## Product Change Notification / JAON-07MXUP507

CCB 4810 Final Notice: Qualification of ATP7 as an additional assembly site for selected Atmel ATXMEGA128A4U, ATXMEGA128D4 and ATXMEGA64D4 device families available in 44L VQFN (7x7x1.0mm) package.

**PCN #: JAON-07MXUP507**

**CCB 4810**  
**Pre and Post Change Summary**  
**PCN#: JAON-07MXUP507**

# Lead frame comparison

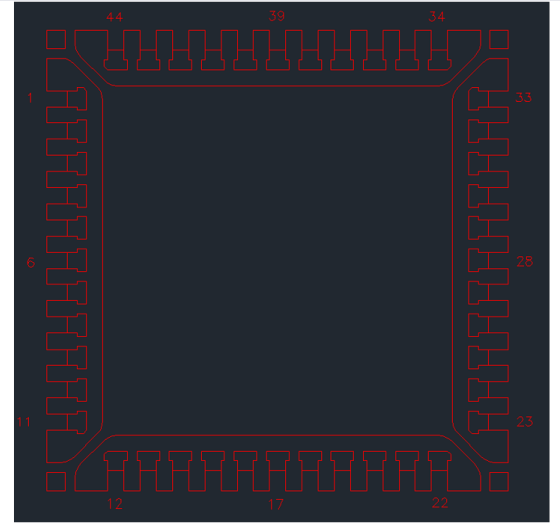
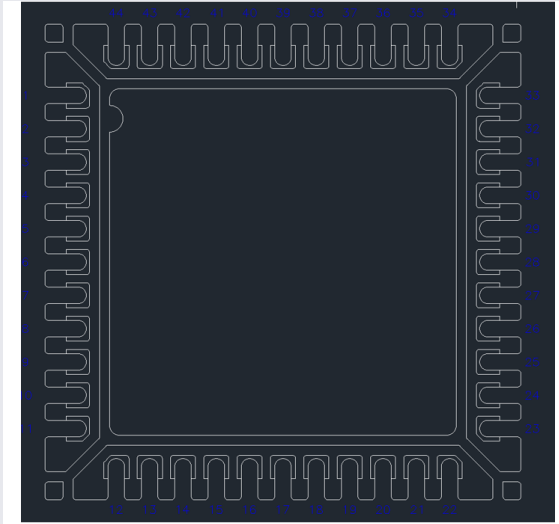
Pre change	Post Change												
ASE	ATP7

<table><tr><td>Lead frame material</td><td>C194</td></tr><tr><td>Lead frame Paddle size</td><td>213x213 mils</td></tr><tr><td>Lead frame DAP surface Prep</td><td>Spot Plating</td></tr></table>	Lead frame material	C194	Lead frame Paddle size	213x213 mils	Lead frame DAP surface Prep	Spot Plating	<table><tr><td>Lead frame material</td><td>C194FH</td></tr><tr><td>Lead frame Paddle size</td><td>217x217 mils</td></tr><tr><td>Lead frame DAP surface Prep</td><td>PPF</td></tr></table>	Lead frame material	C194FH	Lead frame Paddle size	217x217 mils	Lead frame DAP surface Prep	PPF
Lead frame material	C194												
Lead frame Paddle size	213x213 mils												
Lead frame DAP surface Prep	Spot Plating												
Lead frame material	C194FH												
Lead frame Paddle size	217x217 mils												
Lead frame DAP surface Prep	PPF
